From: Lauren Balisky
Sent: Wednesday, November 17, 2021 8:35 AM
To: 'SYLVIA S KAWABATA'
Cc: permittech; Linda Ritter; Garrett Jensen
Subject: RE: Harbor Grove Subdivision Prelim Plat
Attachments: Notice of Application.pdf

Comments in Response to Proposed Development by SEAPAC Homes at 9110 53rd Ave. W, Mukilteo, WA 98275. Dated November 26, 2021.

Comments on Planned Development by Sea Pac Homes at 9110 53rd Ave. W Mukilteo, WA 98275. Dated November 30, 2021

FIGURE
1.2

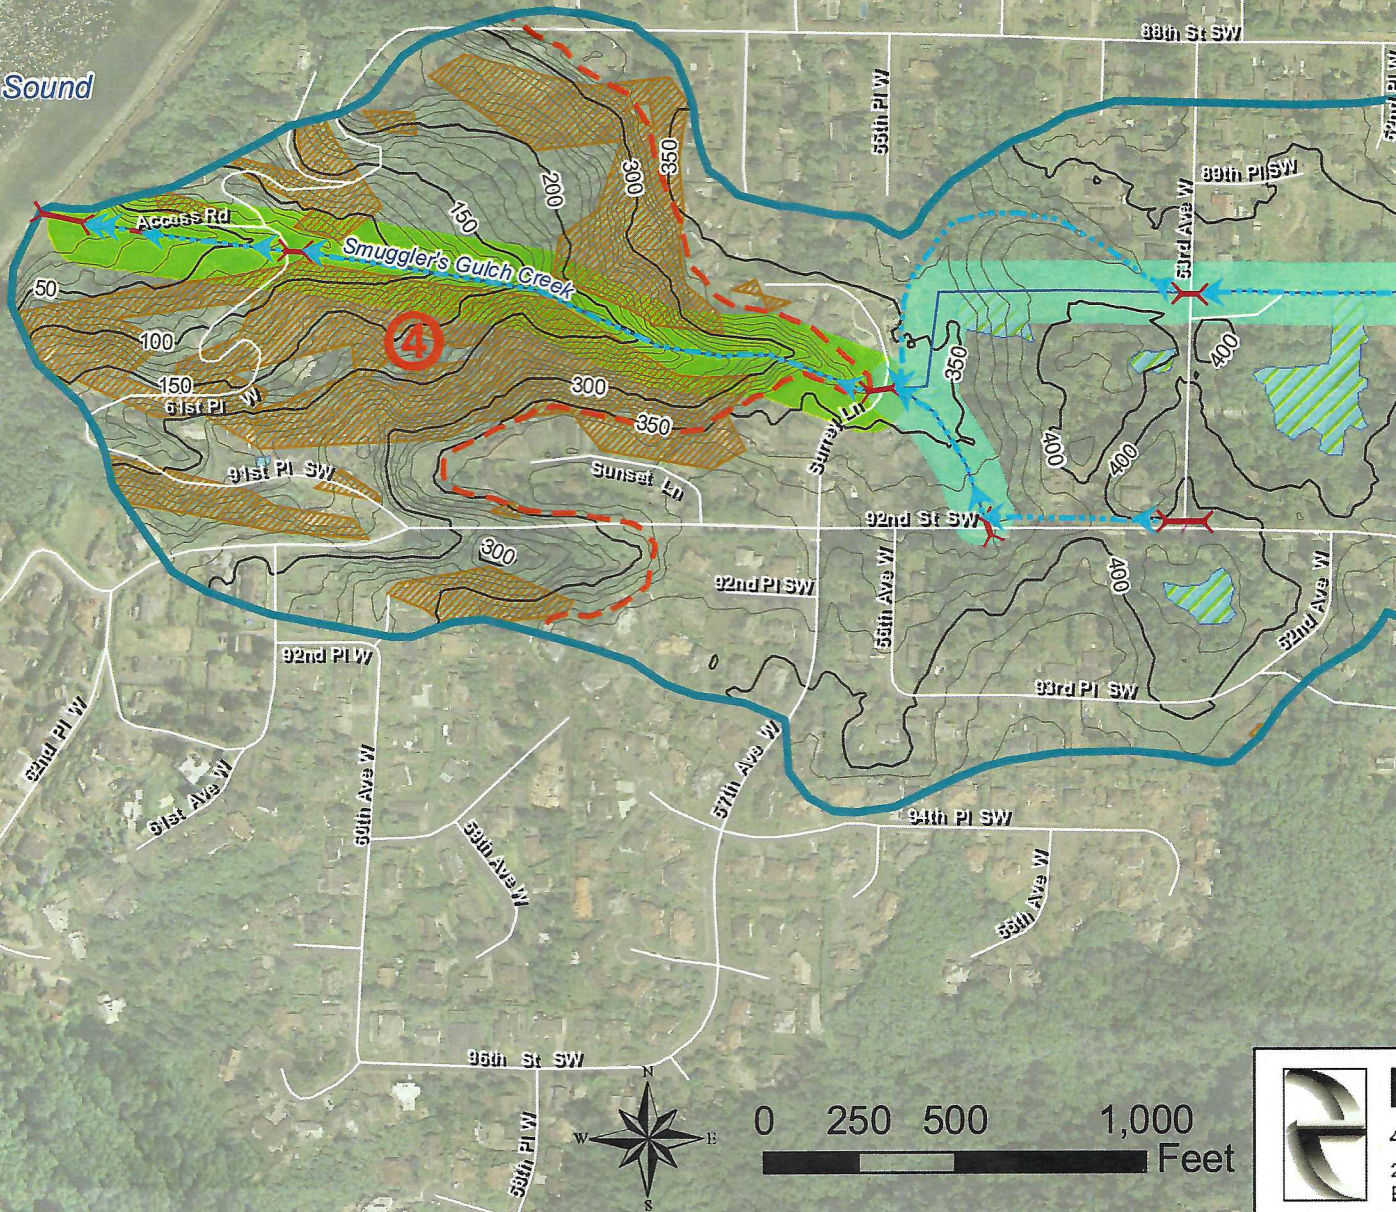
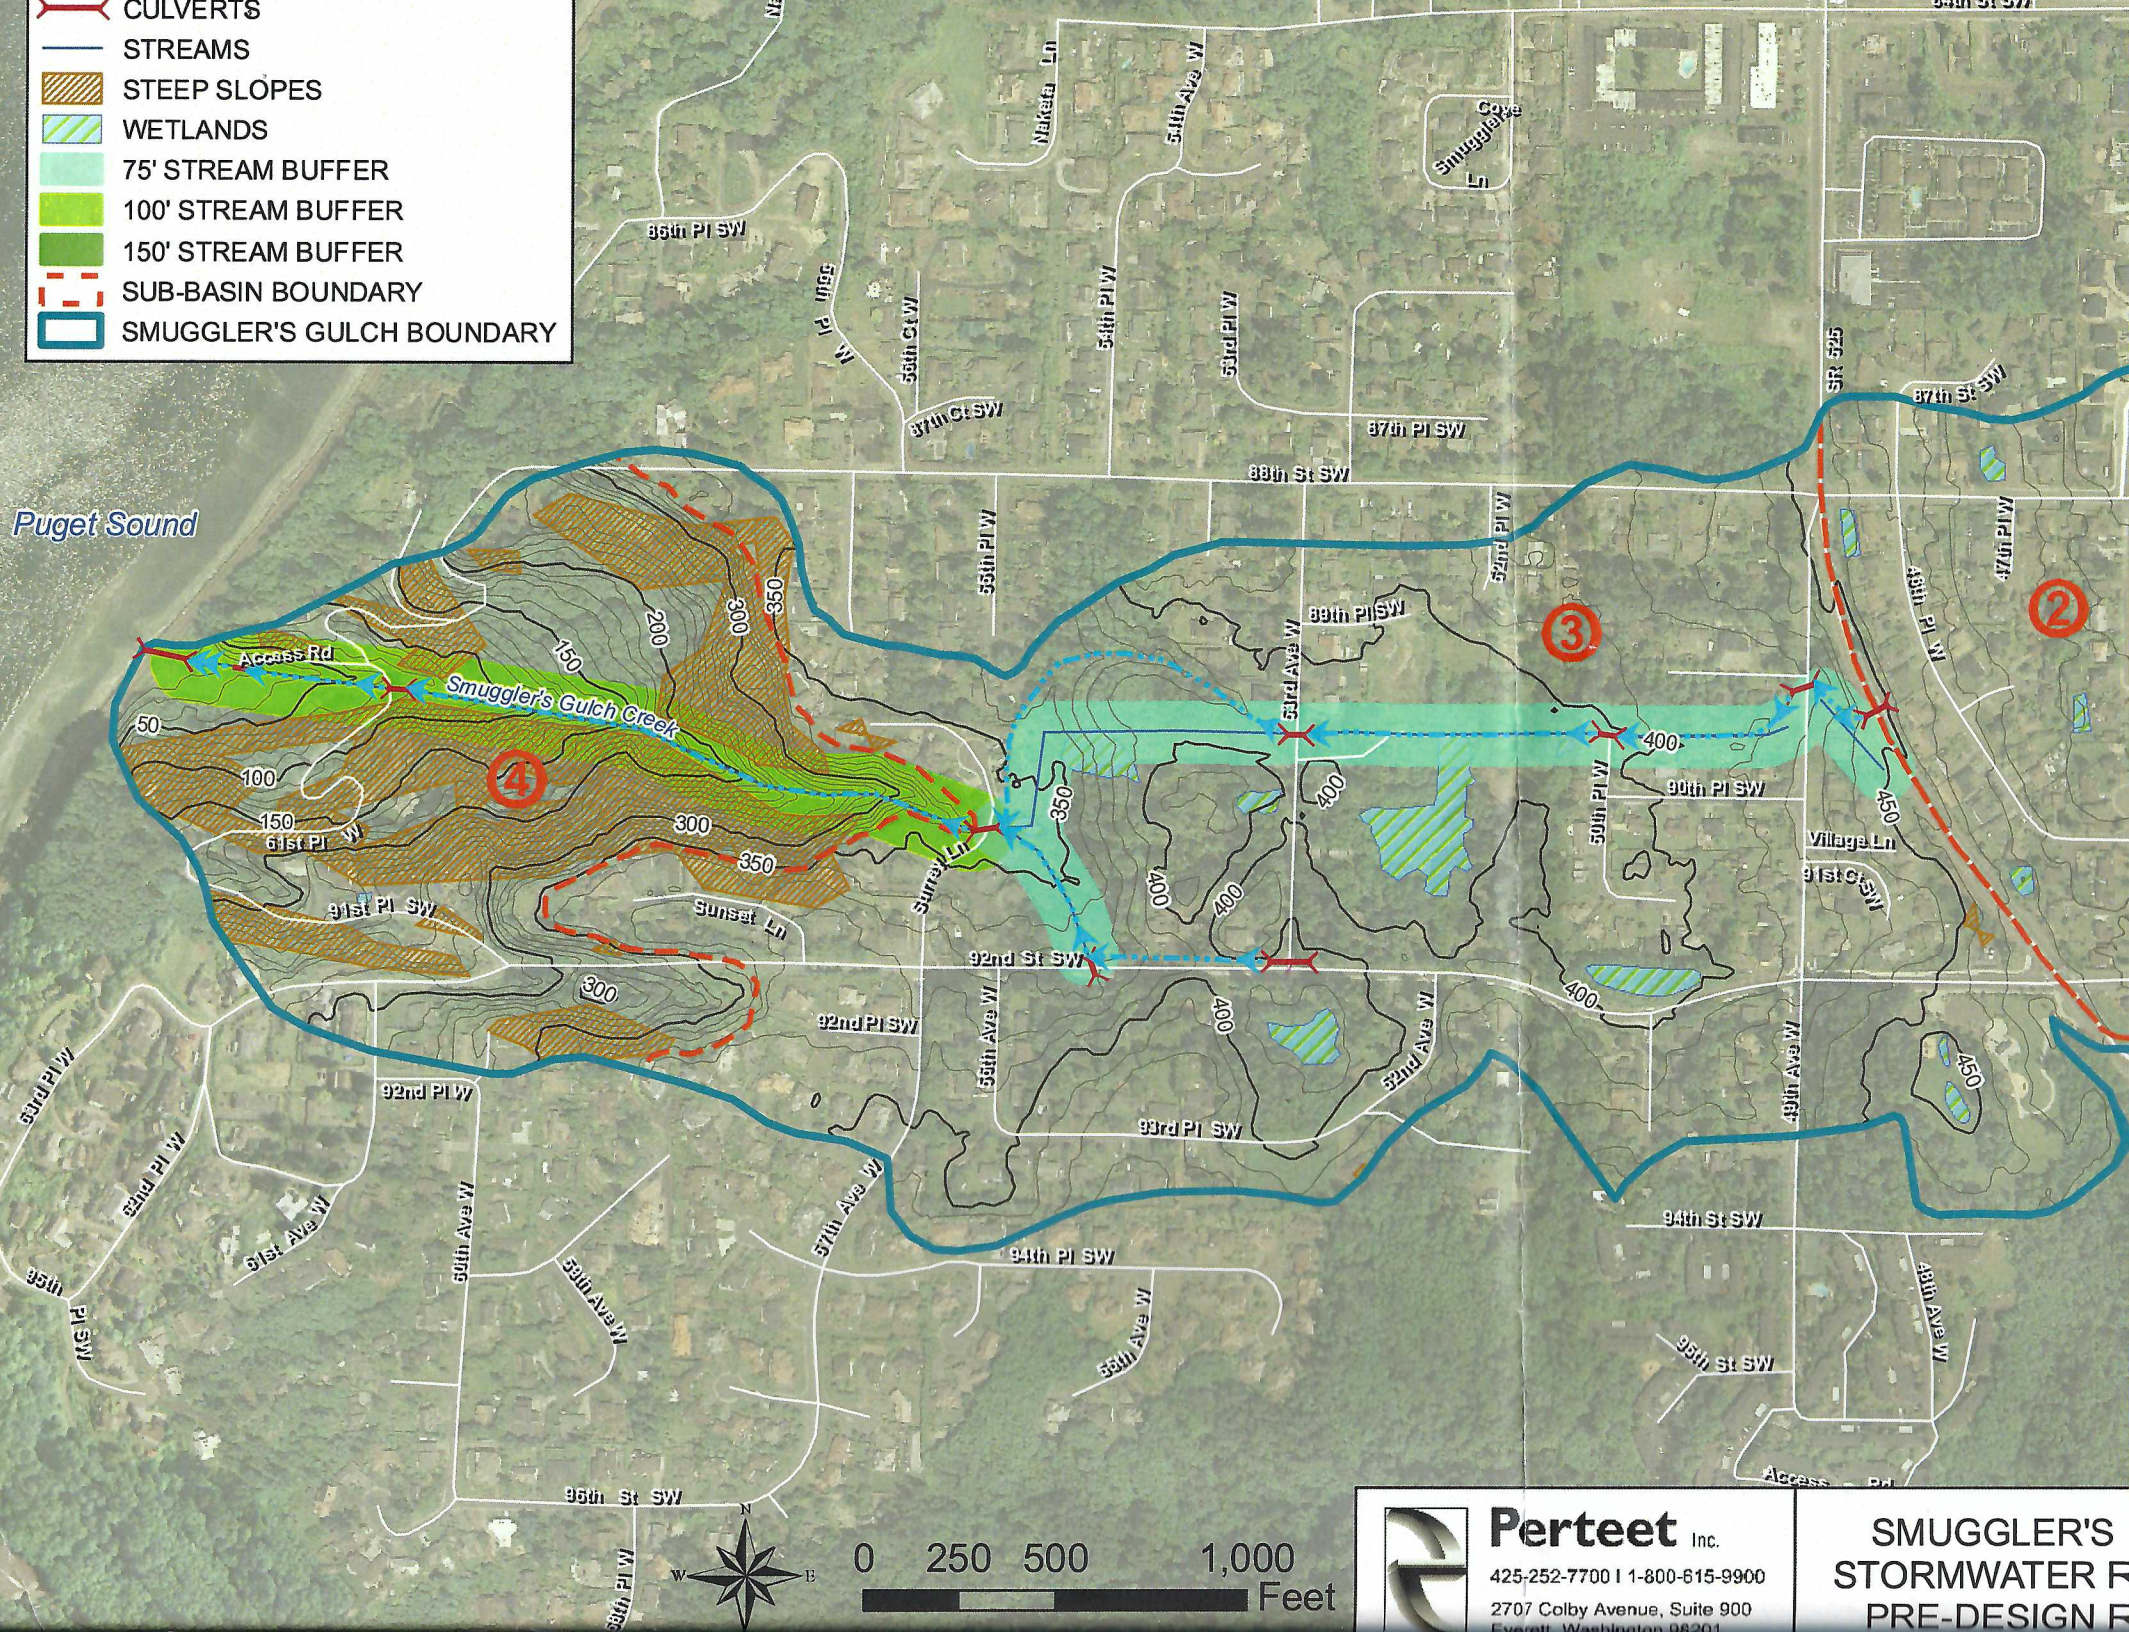
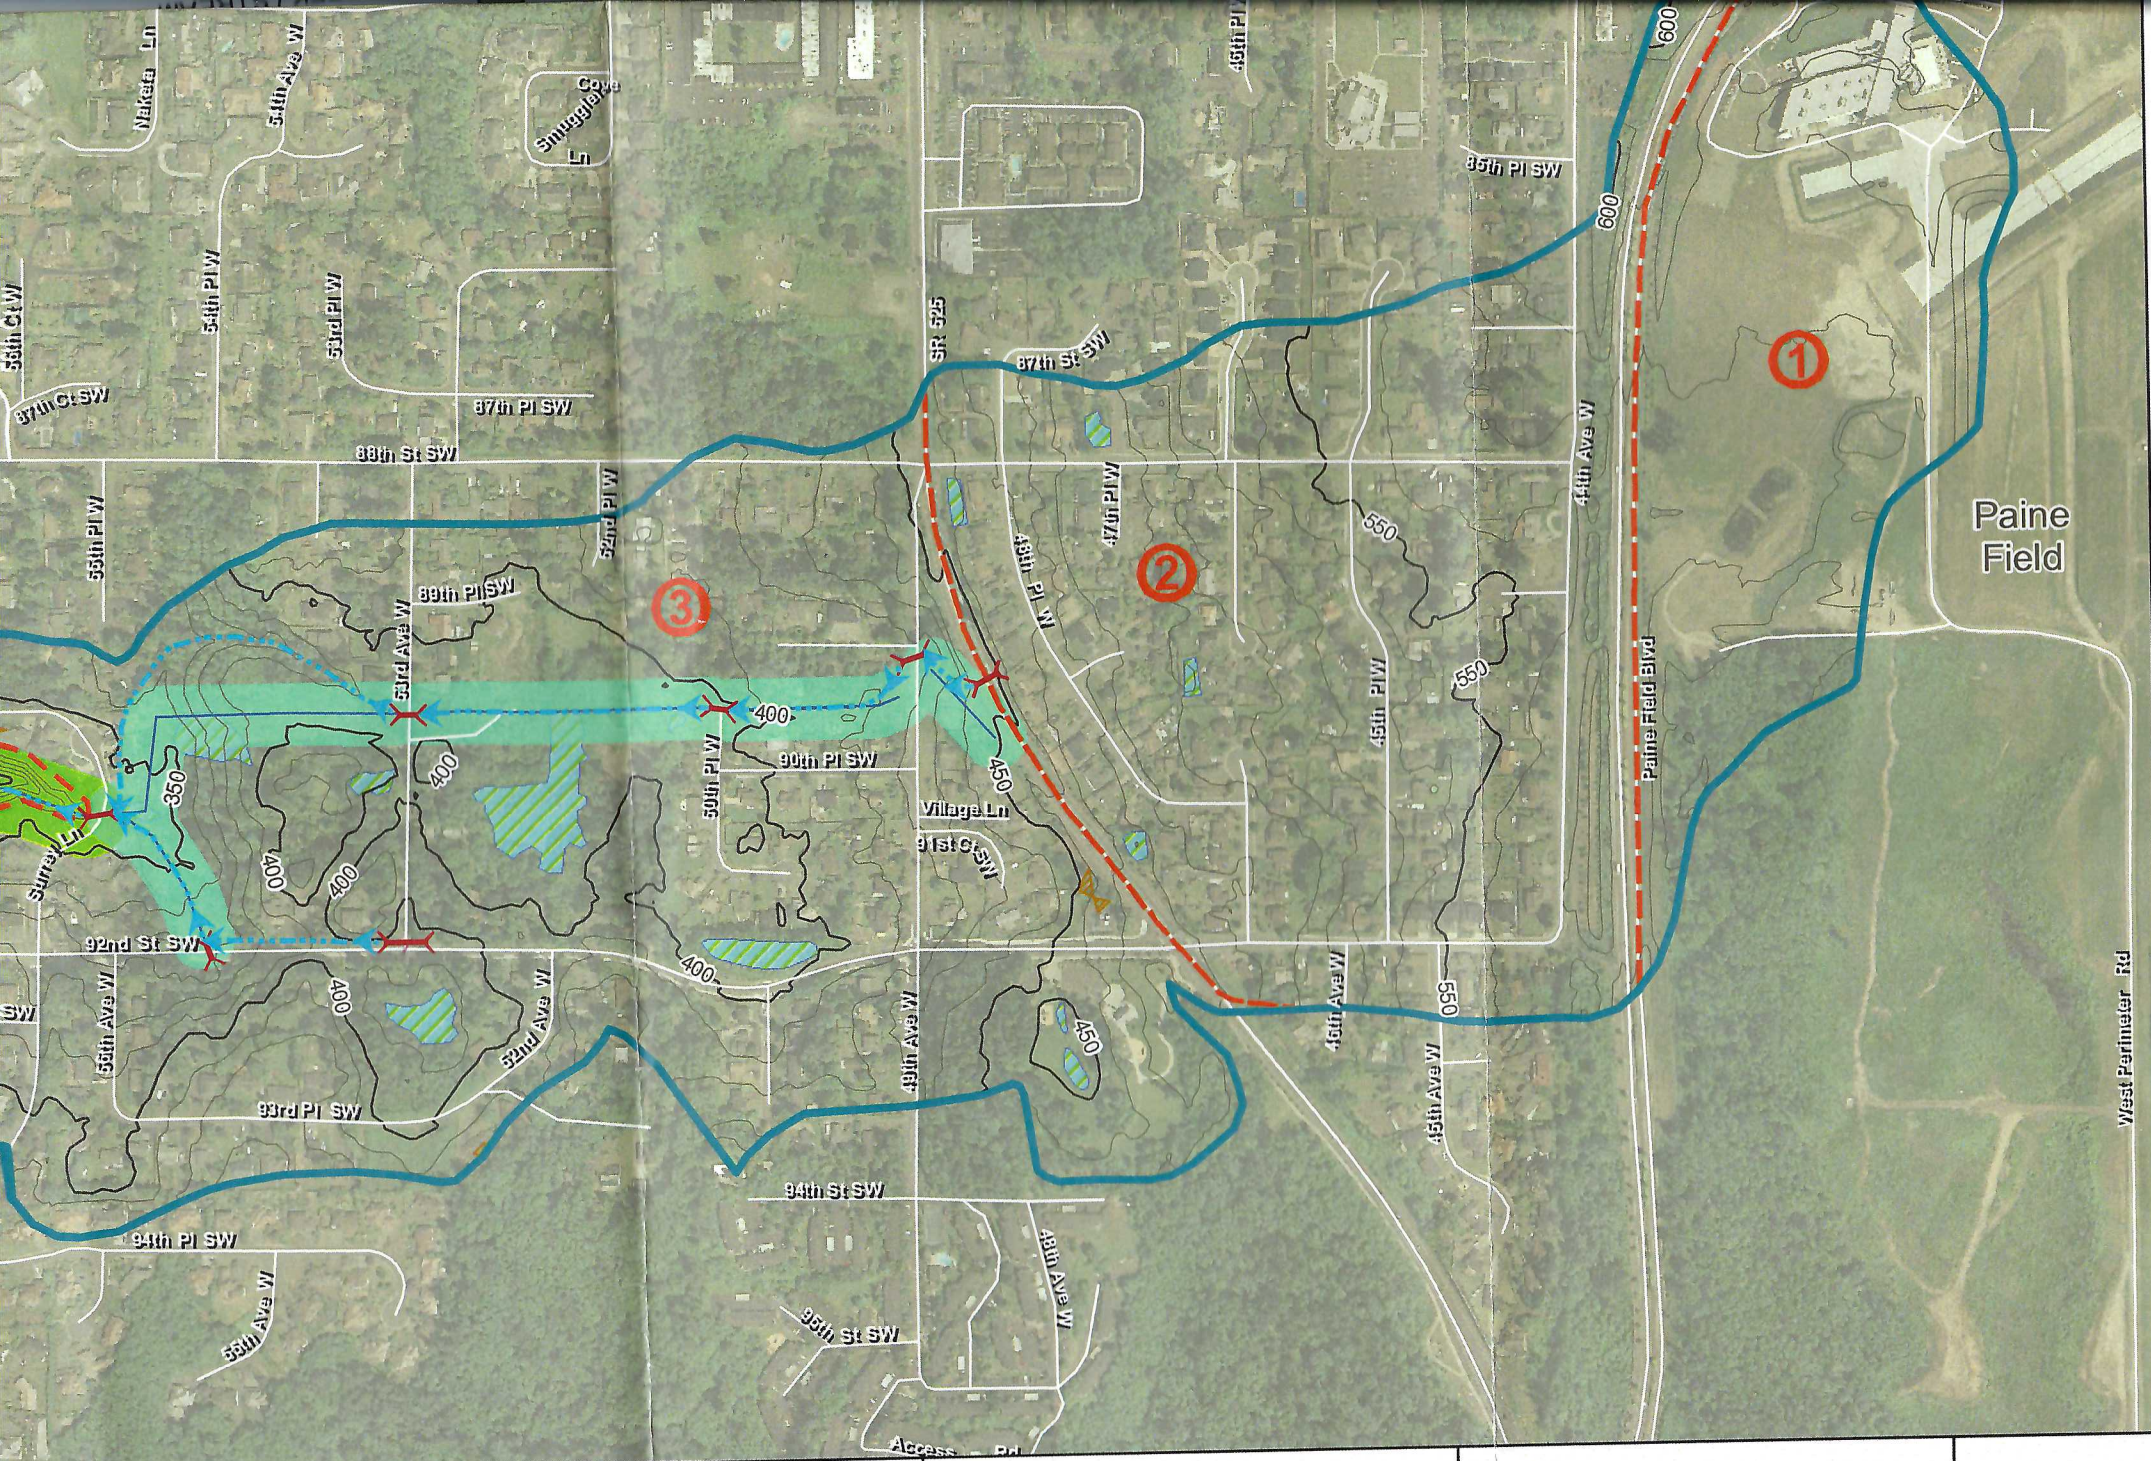
Also, in the City of Mukilteo's Pre-Design Report of the Smuggler's Gulch Stormwater Retrofit Study (dated 8-27-2010, prepared by Perteet) Figure 1.2 identifies a wetland area on the proposed sub-division about 175 feet south of where the creek goes under 53rd Ave W. (A copy of Figure 1.2 is attached.) The applicant needs to address the impacts to this wetland, alternatives to not disturb this wetland and mitigation for its loss if the applicant intends to fill in this wetland area.

Figure 1 - Image showing proposed retaining walls abutting Rugosa Ridge

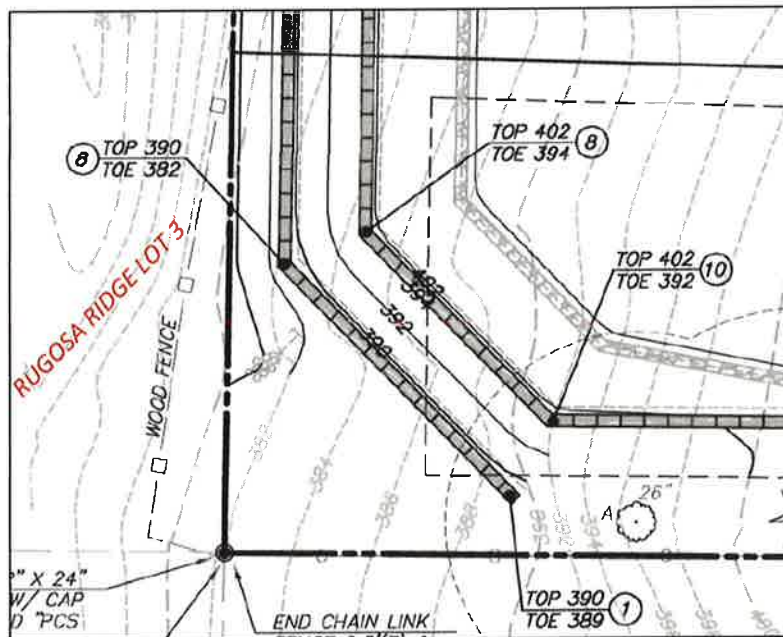
The project includes very large retaining walls along the western boundary of the property. The walls appear to be up to 20 feet in height adjacent to Lot 3 of Rugosa Ridge (see Figure 1 below from grading plan). Not only would the walls be visible from the abutting lots in Rugosa, they would be visible from many vantage points in our subdivision, including from the public street. The walls would be massive and unsightly. For that reason, the HOA strongly opposes the use of large retaining walls supporting large amounts of fill.

Figure 1 – French drain and connection to stormwater collection system

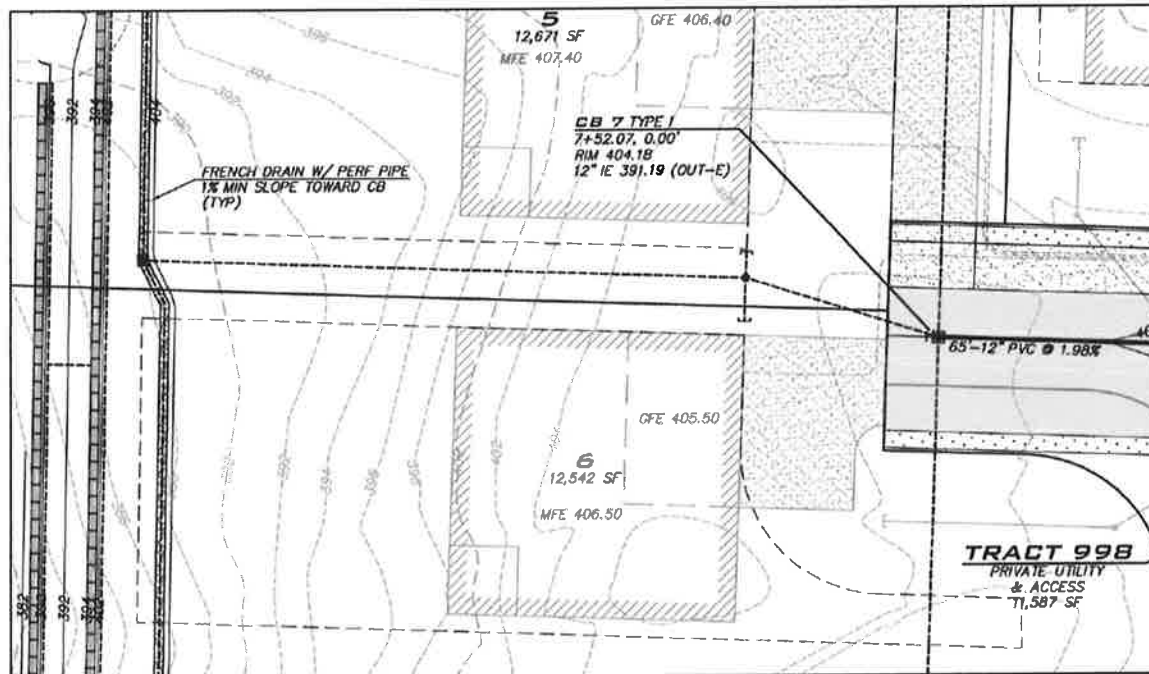
French drain. The proposed french drain to be installed across Lots 4-7 will be buried under approximately 10-12 feet of fill dirt (see Sheet 7 of the preliminary plans and Figure 1 below). How will this drain be maintained? What will happen if it fails? Will it be possible to bring equipment into the back yards of future homeowners and dig a 12 foot deep trench? Future property owners will have no incentive to maintain the drain systems because failure would mostly impact other properties outside of the development. My guess is this drain will never be maintained or repaired, and if it fails, it will cause major drainage issues for my property and my neighbors. Such a failure would be nearly impossible to detect and locate, much less to fix. There is also a possibility that future homeowners will cover the drain area with patios and other hard surfacing, making it less effective.

The french drain will flow back to the east in a pipe connected to the detention system. The slope gradient of this pipe is specified at a minimum of 1%, which is barely enough for the water to flow in its intended direction (see Sheet 7). In order to flow back to the east, this drain will need to be installed at a minimum elevation of 393' because the catch basin elevation will be set at 391' (Sheet 7 and Figure 1, below). The french drain collection pipe will be *above* the existing grade level of approximately 386' to 392'. This is significant because the drain will be at too high of an elevation to capture all of the site's subsurface drainage. It would be located above the layer of glacial till that underlies the site. Because of the site's sloping topography, water is likely pass *under* the pipe, contact the glacial till layer, and migrate to the west. And what would happen if the site were to experience post-development settlement, changing the gradient of the pipe? Could it potentially stop flowing? These are valid questions since the proposal is to place a massive amount of fill material on the site.

The effectiveness of this project's subsurface drainage system will be reduced as a result of the applicant's design objective of sending collected water back to the east. System improvements, including the french drain, would be installed at too high of an elevation. The City should require the applicant to prepare an alternative design that places the subsurface drainage collection system at a lower elevation to more effectively capture subsurface water. The design should be prepared in close coordination with a groundwater study and a revised soils study. Long-term access and maintenance provisions should be included for this or any system.

Figure 1 – Detention Vault “Bypass Basin” Area (highlighted in yellow)

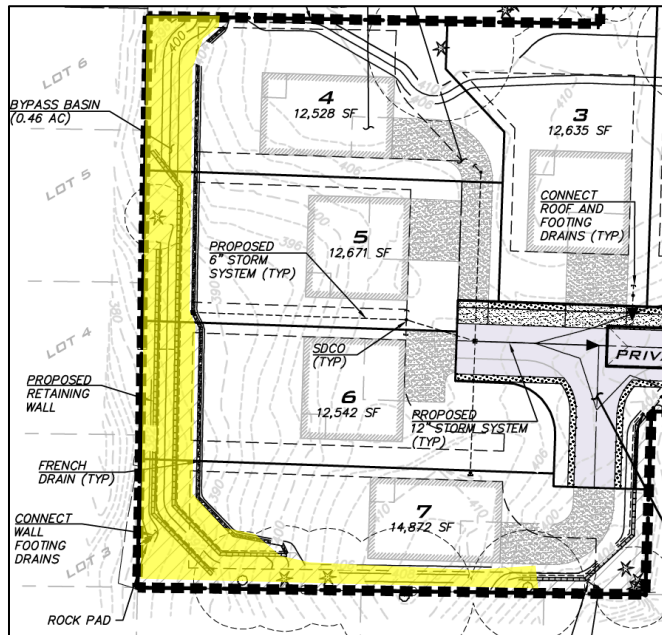
- C. Bypass Basin. The drainage study identifies a "bypass basin" consisting of 0.46 acres of land that will not drain to the detention vault (see pages 4.3, 4.4 and Developed Conditions Exhibit and Figure 1 below). This area is located along the west and south property lines of the project site and directly abuts several properties in Rugosa Ridge. The drainage study contains no analysis of potential impacts on adjacent properties and must be amended to address this issue since nearly 20% of the developed project site will bypass the storm system and flow to adjacent properties. The amount of runoff generated post-development from the bypass basin would exceed runoff from existing

conditions as a result of removal of all existing vegetation. This information also supports a requirement for a groundwater study.
